Note Response to Anonymous Referee #1

Interactive comment on “The yearly amount and characteristics of deep-buried phreatic evaporation in hyper-arid areas” by H. Li et al.

Anonymous Referee #1

Fig. 2. Sketch map of the GSPAC water movement and condensation in the greenhouse (2009).

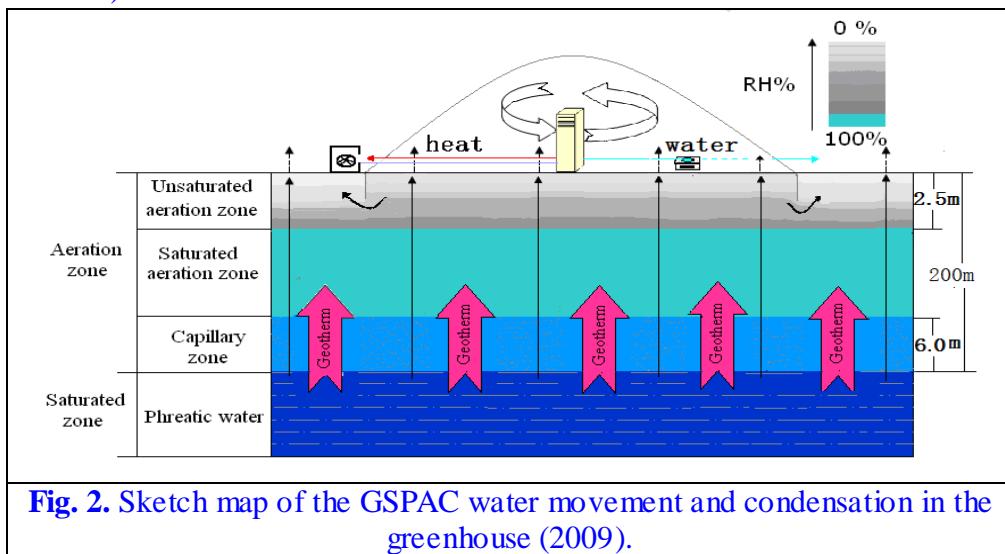
6. Section 3.3: Comparison between the temperature and humidity data inside and outside the greenhouse shows that temperature, but most importantly humidity, is constantly lower inside than outside. This, combined with the fact that when it rains there is no infiltration under the greenhouse, make me suspect that the air conditioner in the greenhouse is extracting soil moisture laterally, as Figure 4 would suggest. Water vapor could be even recalled from the outside atmosphere through the shallowest layers of soil (but deeper than 30 cm), being the latter basically dry and thus prone to conduct gases. Therefore, the evaporation is likely to be overestimated and possibly related to the annual amount of rainfall in the area. As a matter of fact, I would like to see whether or not there is a significant correlation between annual rainfall and annual evaporation.

Yes, the temperature and humidity is constantly lower inside than outside, there is a slight water vapor comes from outside. But not the air conditioner in the greenhouse is extracting soil moisture laterally.

The reviewer maybe not read the conference papers (see “*The daily evaporation characteristics of deeply buried phreatic water in an extremely arid region*”. *J. Hydrol.*, 514 (6):172–179; and “*Measurement of deep buried phreatic water evaporation in extremely arid area*”. *Acta Ecol Sinica* 30: 6798-6803) in **Fig. 2, Table 2** and that context we detailed instructions this in that articles, because of shed-effect, soil temperature and humidity in the shed/greenhouse higher than the outside soil, there is no lateral water *into* the greenhouse. In the greenhouse we are measured a part of the PE, a small amount of PE through lateral flow in the outside world. Soil temperature and humidity in the whole process of the 45 d monitoring show that soil in greenhouse has been higher than the outside’s (see **Fig. 2, Table 2**).

In this time the average quantity of PE recorded (827 g d^{-1}) is 25.9% larger than that recorded during the 45-day experiment in 2009 (Li et al., 2010b) for the same period (May 22 to July 5). This is because of the greater power of the new air-conditioner. Even if water came from outside, it will not more than 25.9%. See Table 3. The comparison of the average temperatures, RHs, and AHs inside and outside the greenhouse (2010):

Fig.3. The daily change of soil water content in Gobi soil (2007-6-12).

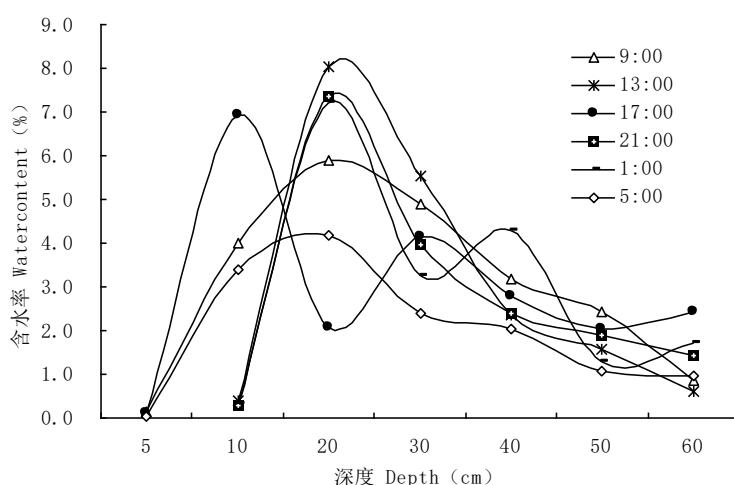
5. Section 3.2: it is not possible to assess daily fluctuations of soil moisture from Figure3. I strongly recommend that the complete and continuous time series of soil moisture at different depths be reported.

9. Section 4: the Discussion section should be rewritten according to the previous suggestions. At present, daily fluctuations of temperature and soil moisture are not shown; therefore it is difficult to follow discussions such as the one reported in Section 4.1. Similarly for Section 4.2, I am not able to see any connection between the data reported in Figure 3 and soil moisture hysteresis.

In these paper, the daily water content variation was shown as Fig. 3, the daily temperature and humidity was shown as Fig. 4.

We cannot insert all the figures in this one paper. If you have read our related research paper (as in the reference), we think the discussion part is clearly.
